# VILLAGE OF KIMBERLY, WI NOTICE OF VILLAGE PLAN COMMISSION MEETING

# Village of Kimberly Request for Plan Commission Recommendation

# Village of Kimberly Request for Plan Commission Recommendation

ITEM DESCRIPTION: Site & Architectural Review – Footworks Dance Company 103/109 W Kimberly Avenue

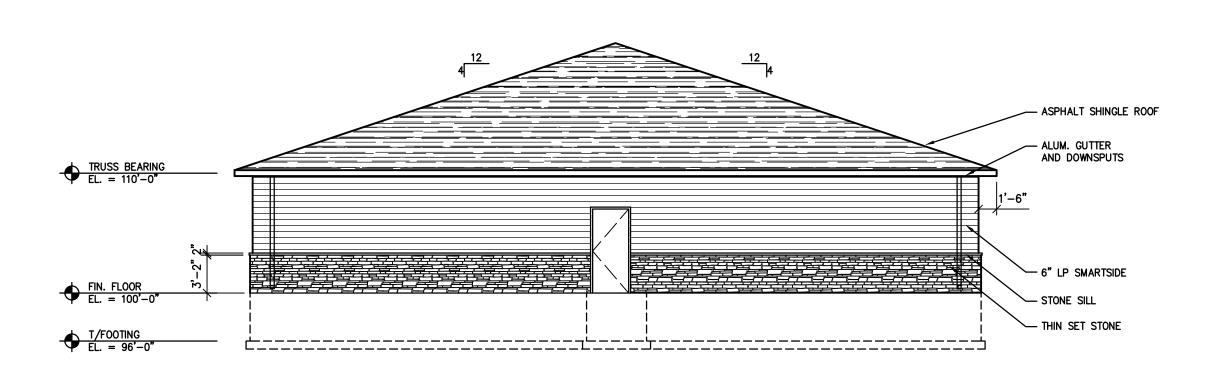
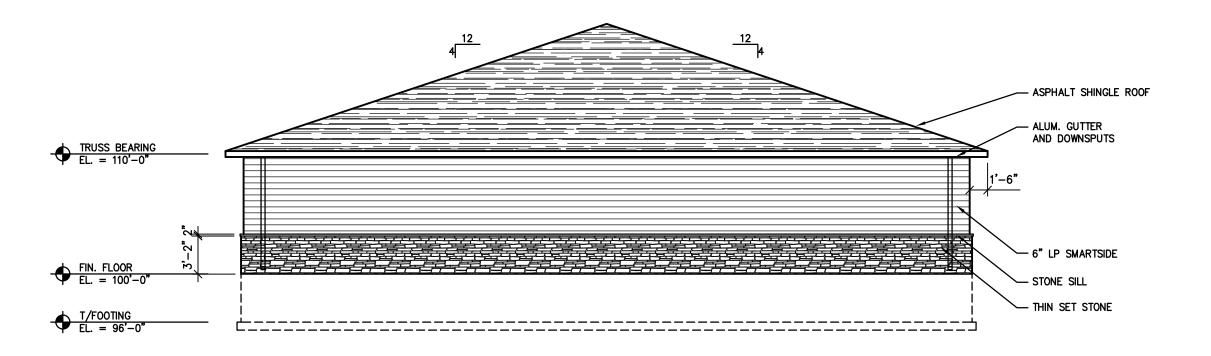
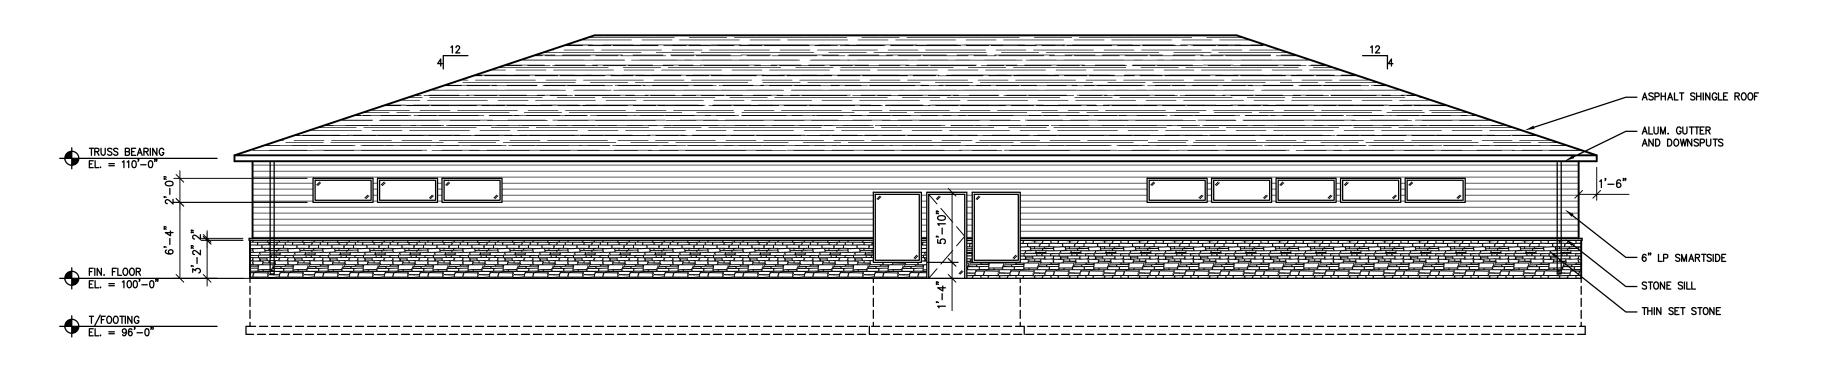
- Facade. Due to the location being directly located in the Village of Kimberly downtown, staff does believe some additional architectural elements can be added to improve the exterior appeal.
   These elements can be dormers, additional windows, additional building landscaping, modification of brick work, etc.

- 1. Additional façade elements shall be considered prior to the issuance of building permits to break up the long expansive walls and roof line.
- 2. All lighting shall be full cutoff unless it is less than 1,200 lumens and meets Village Ordinance.
- 3. A solid fence shall be provided within the buffer yard and the proposed landscape materials shall not be less than 5 feet tall at the time of install.
- 4. Additional landscaping or planter boxes shall be provided along the front of the building.
- 5. The 3 foot asphalt strip along the alley shall be removed and blended with the green space.
- 6. Grading of the site shall be verified to ensure no negative impacts to the surrounding residential development.
- 7. Any refuse beyond standard residential carts shall be screened from off-site view and be located in the rear of the building.
